LAND USE PRE-APPLICATION CONFERENCE Thursday, January 6, 2011

Planner: Tom Soppe Project #: PA-10-36

City of West Linn PRE-APPLICATION CONFERENCE MEETING Notes

Water Resources Area permit and Class II Variance for new house on

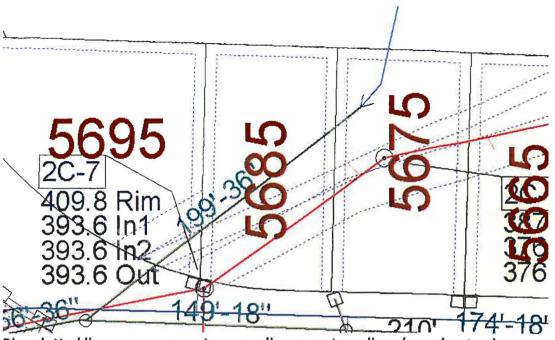
See the map below showing the aforementioned utilities and easements on site. This map also shows the 6-foot-wide utility easements along the rim of each side of each lot in this subdivision, as designated by the notes on the plat for Serango #1. Because of this standard perimeter easement, the variance application can be for no more than a 6-foot rear setback, instead of the 5-foot one the applicant shows on the site plan.

Blue dotted lines are easements, green lines are storm lines (opening to above ground section of creek next door), darker blue solid line is water line, red lines are sanitary sewer lines

The City Engineering Division would like to have the stormwater easement location corrected. The applicant is cooperating with the goals of the Engineering Division by proposing a 15 foot stormwater easement over the actual storm line/piped creek on site, as shown on their site plan.

Tinseth 5685 Summit Street-Water Resource Permit Drawing

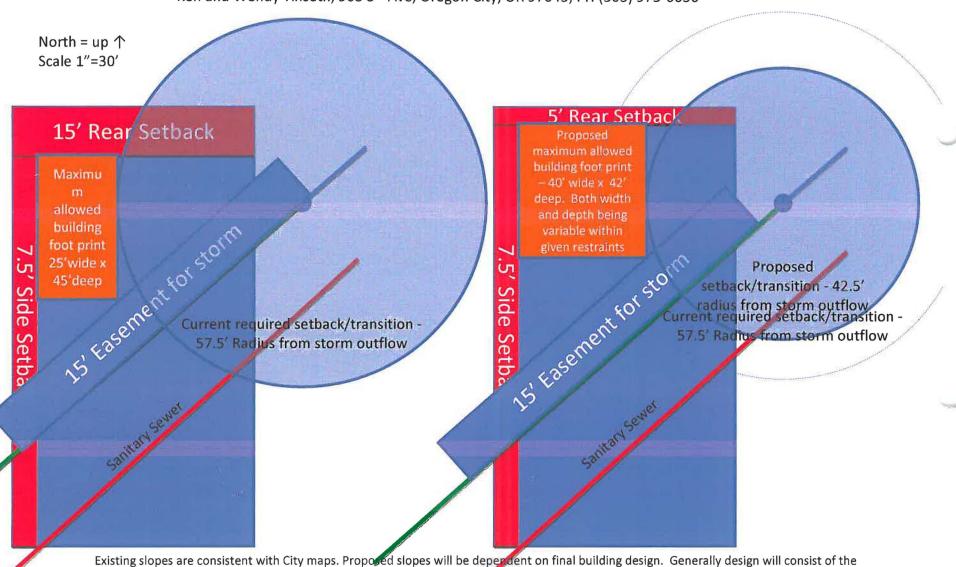
The applicant shows 15 feet as the standard setback on the submitted information. This is the R-10 zone and 20 feet is the standard rear setback except for Planned Unit Developments (PUD). Staff cannot find in the original file for this subdivision (SUB-77-18) where it is applied for as a PUD and/or otherwise has any alternative setbacks allowed. Unless the applicant can prove otherwise, staff assumes that 20 feet is the required setback, so any variance applied for shall be presented in relation to the 20 foot standard. (I.e. a desired 6 foot setback being presented as a 14-foot deviation from the standard rather than a 9 foot difference).
